Technical Service Bulletin: TSB190213Released Date: 09-Dec-2019New Crankcase Pressure Relief Valve: Fault Codes 555 and 556

New Crankcase Pressure Relief Valve: Fault Codes 555 and 556

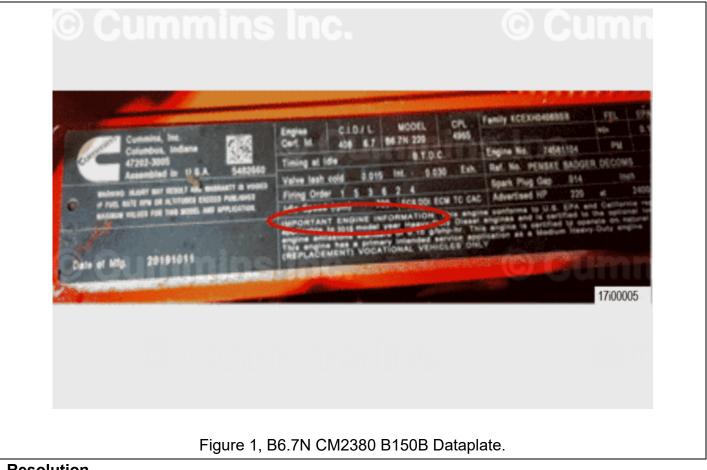
- On B6.7N CM2380 B150B engines only:
 - Verify that the engine is model year 2018 or 2019 by looking in at the engine dataplate.
 - Figure 1 below shows the layout of a B6.7N CM2380 B150B engine dataplate.
 - The year listed in the text of the "IMPORTANT ENGINE INFORMATION" field will indicate the model year of the engine.
 - This Technical Service Bulletin does **not** apply to B6.7N CM2380 B150B engines with a model year other than 2018 or 2019.
